ADDENDUM NO. 2

San Antonio Water System

Project Name: **Olmos Basin Central Watershed Sewer Relief Line (C-3), Reaches 1 to 4**

Project No.: **08-2512**

SHEET NO. **C-102**
15 OF 123

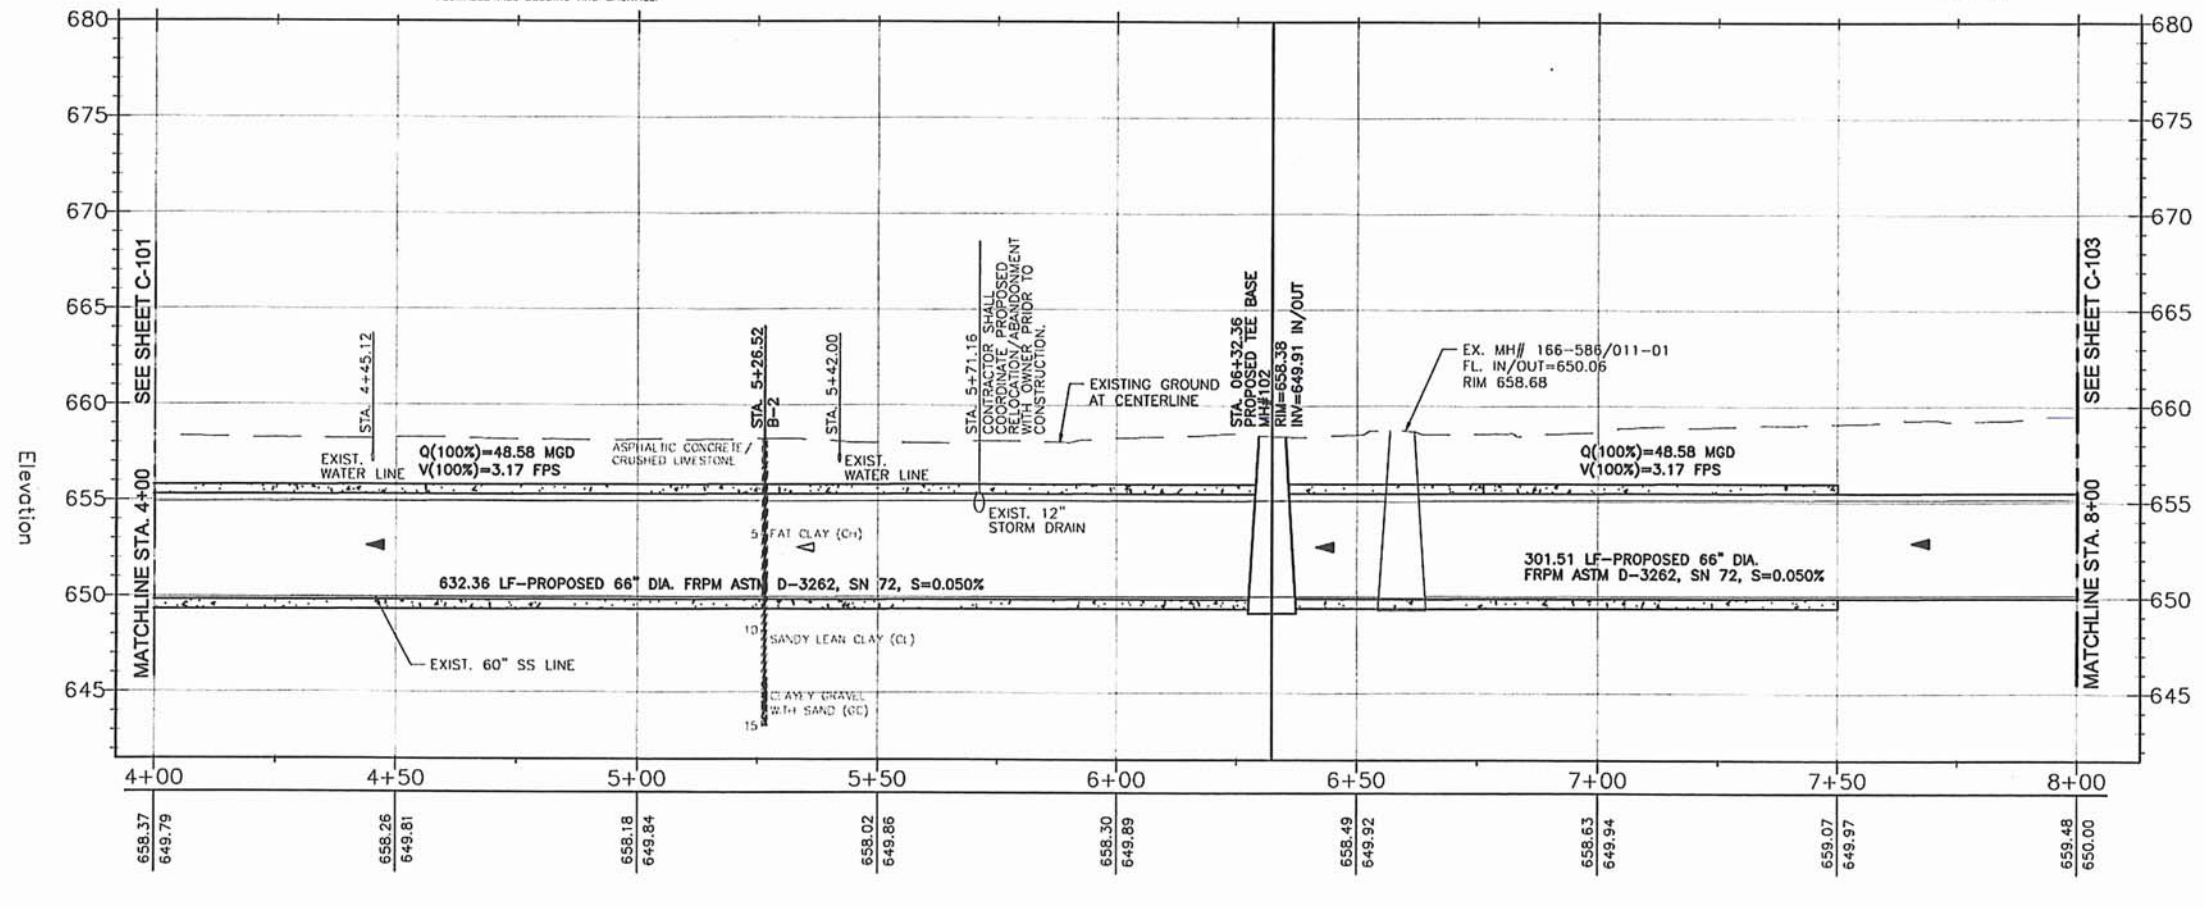
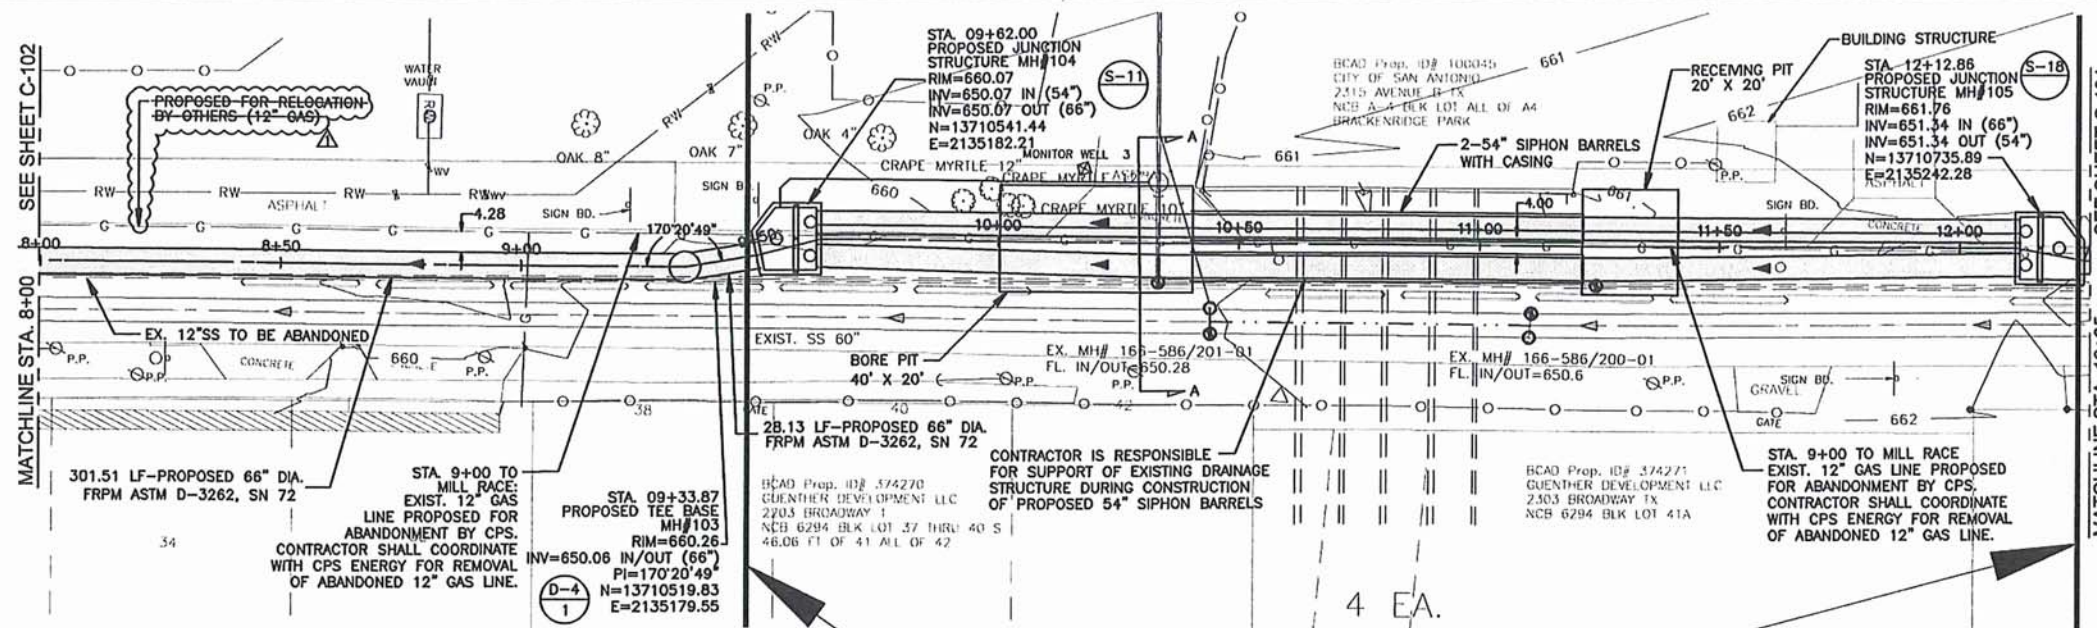
Item 4: Sheet C-101, C-102, and C-103 – Remove and replace Sheet C-101, C-102, and C-103 with the revised Sheet C-101, C-102, and C-103 attached to this addendum. Revisions include:

- a) Delete callout on existing 12” gas line that reads:
“PROPOSED FOR RELOCATION BY OTHERS (12” GAS)”.
Note that the existing 12” gas line on Reach 1, from approx. Sta. 9+00 to approx. 14+50, is planned for abandonment by CPS prior to this SAWS Olmos C-3 project.

NOTES	INITIALS	DATE
DESIGNED BY	AH	10/18/11
REVIEWED BY	MRJ	10/18/11
SCALE:	AS SHOWN	
SHEET NO.	C-107	
	20 OF 123

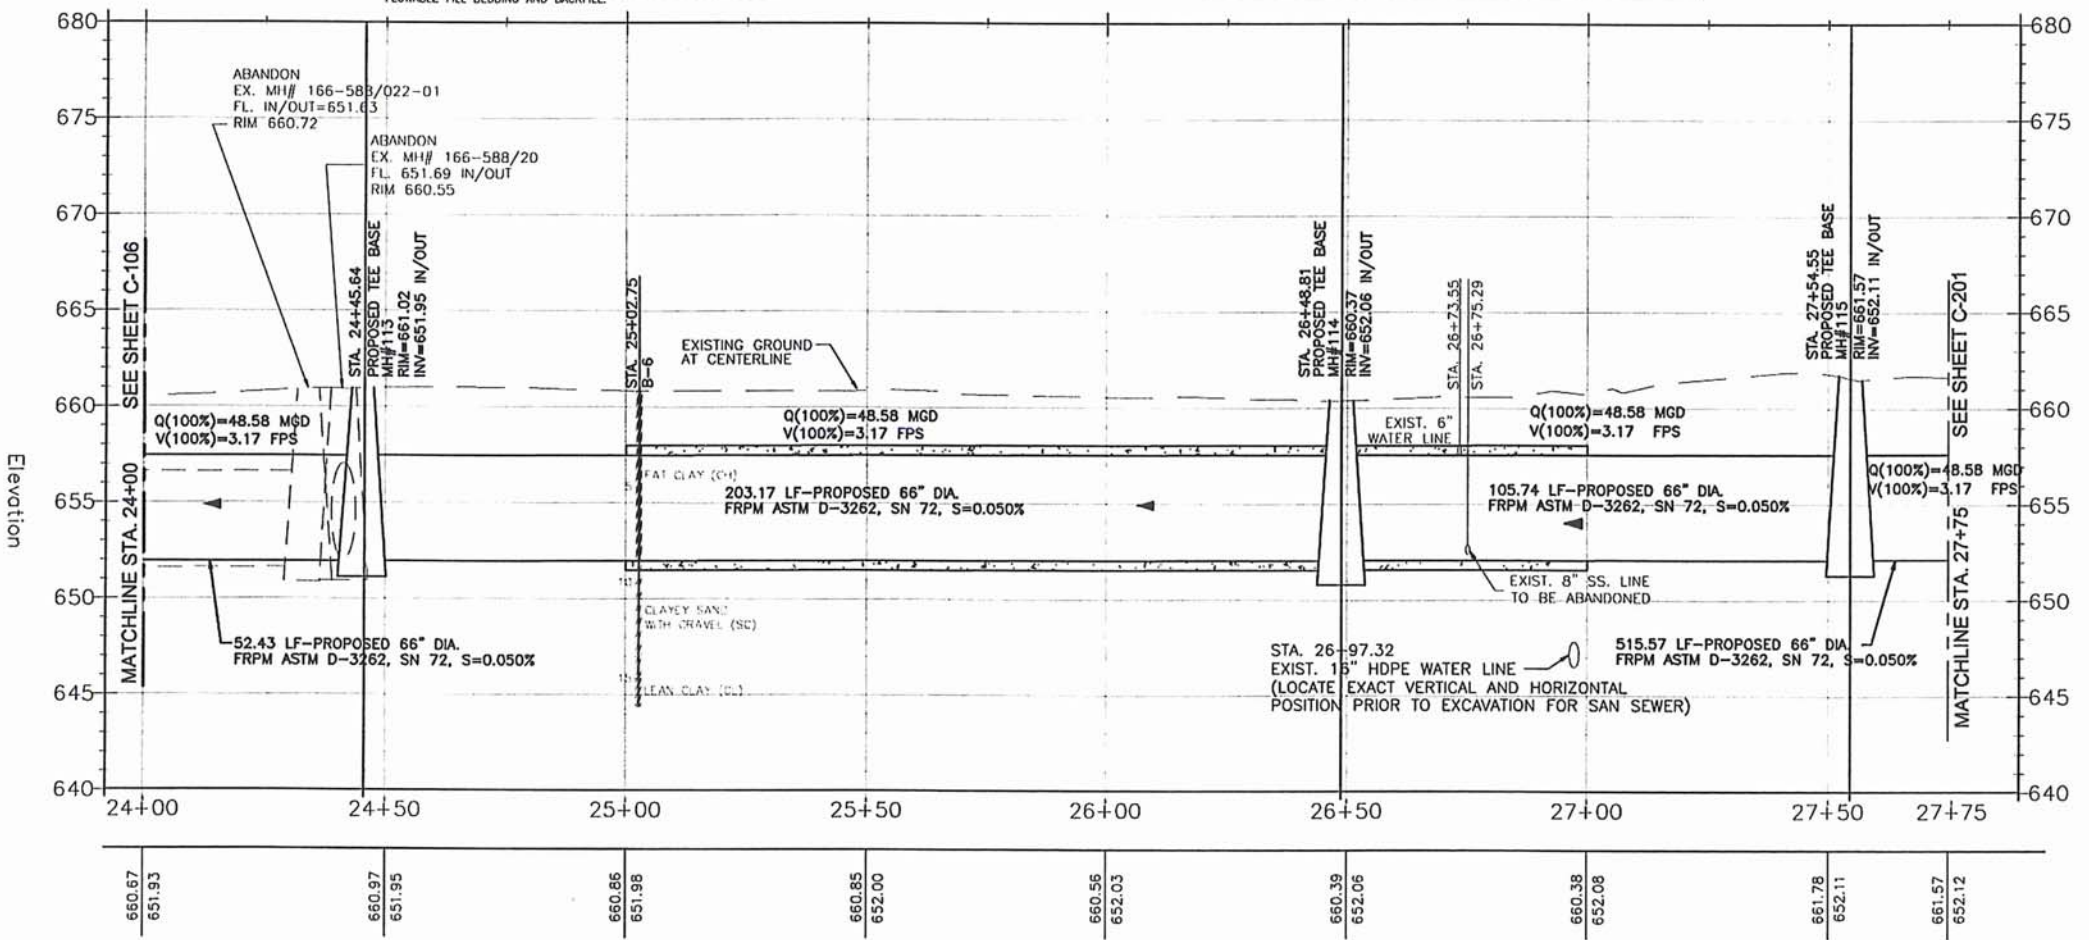
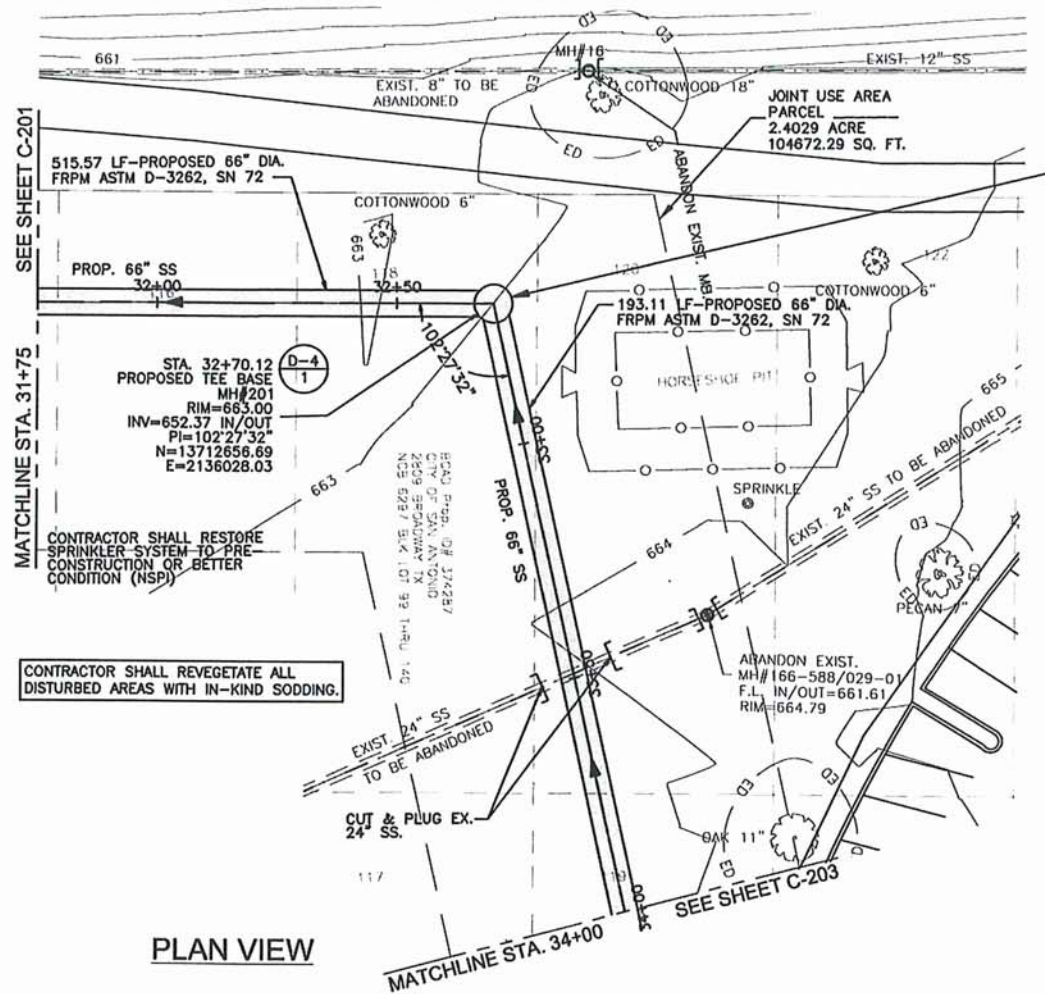
Item 5: Sheet C-107 – Remove and replace Sheet C-107 with the revised Sheet C-107 attached to this addendum. Revisions include:

- a) Add callout label for elevations on existing manhole, MH# 166-588/018-01:
“RIM=660.60
8” IN/OUT=652.35
4” IN=656.60”

SHEET NO. C-202
22 OF 123

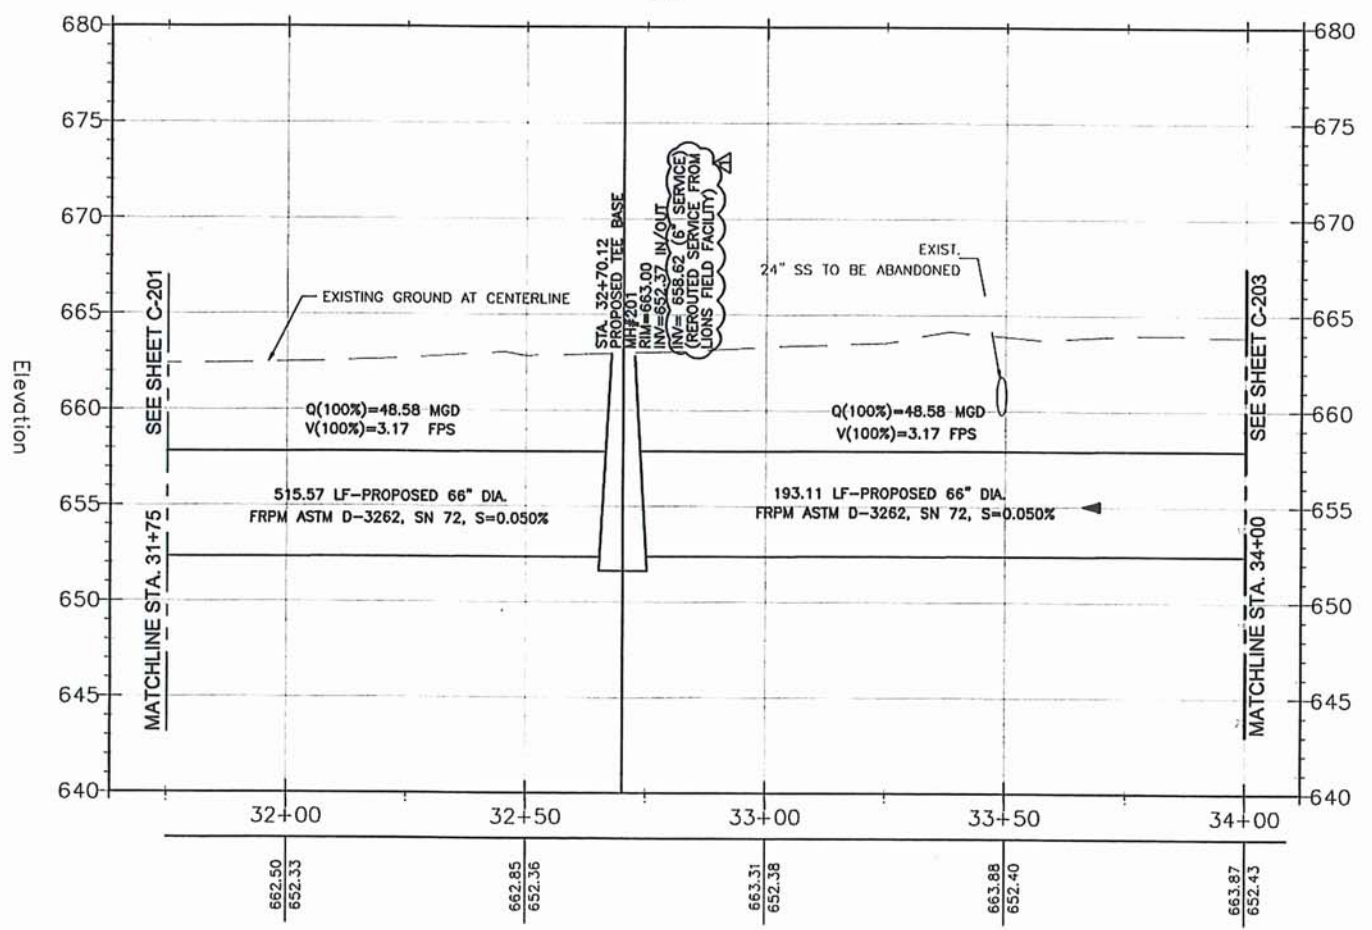
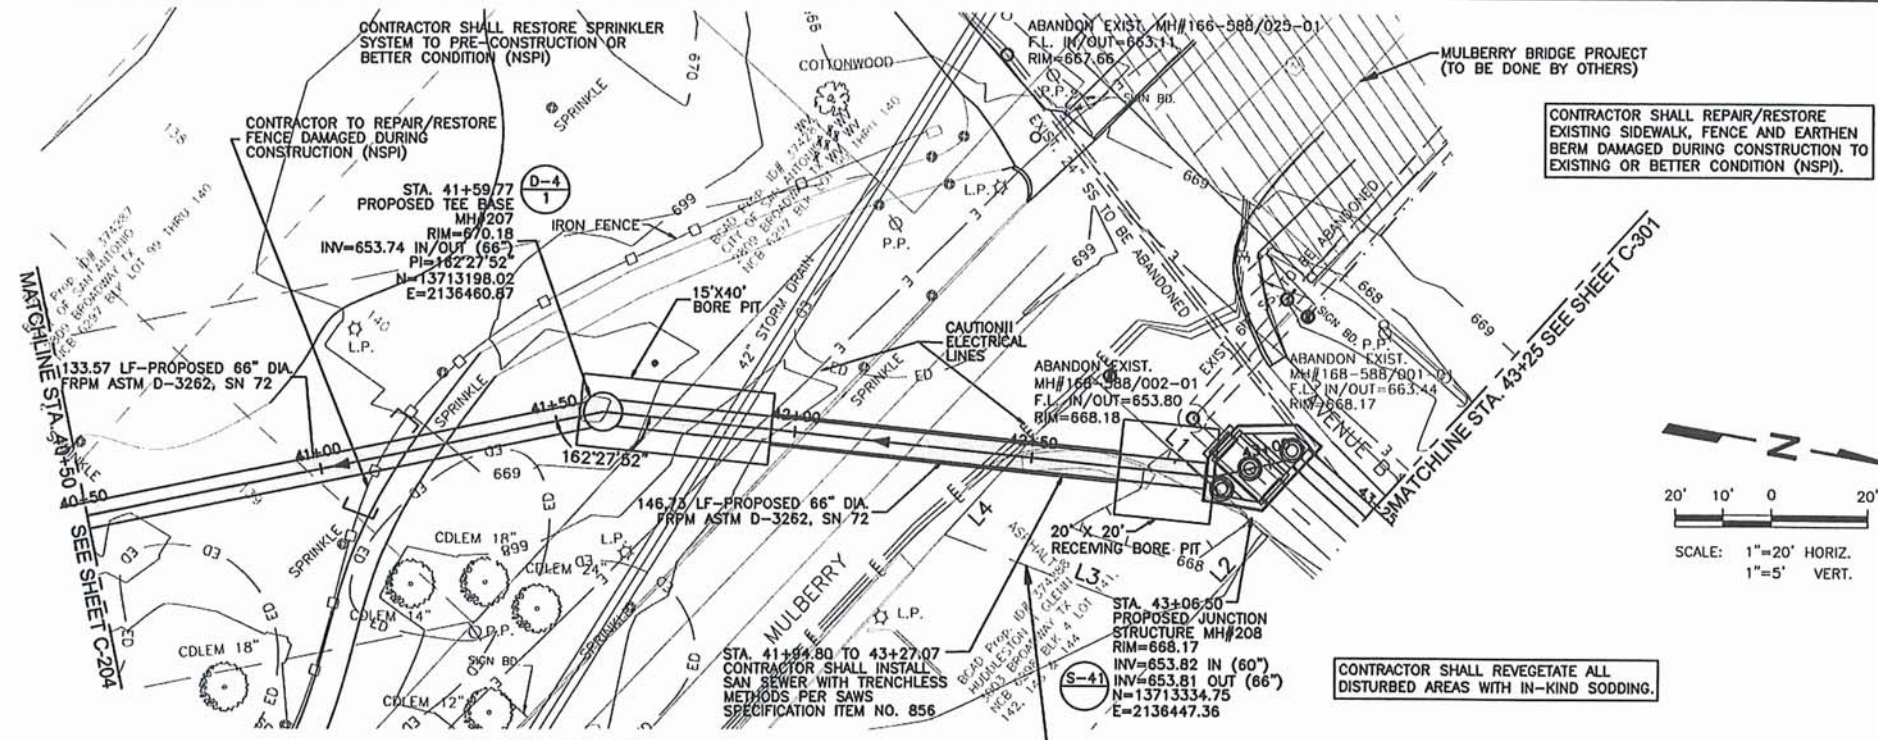
Item 6: Sheet C-202 – Remove and replace Sheet C-202 with the revised Sheet C-202 attached to this addendum. Revisions include:

- a) On plan and profile callouts for proposed MH#201 add the following invert elevation:
“INV(6” SERVICE)=658.62 (REROUTED SERVICE FROM LIONS FIELD FACILITY)”
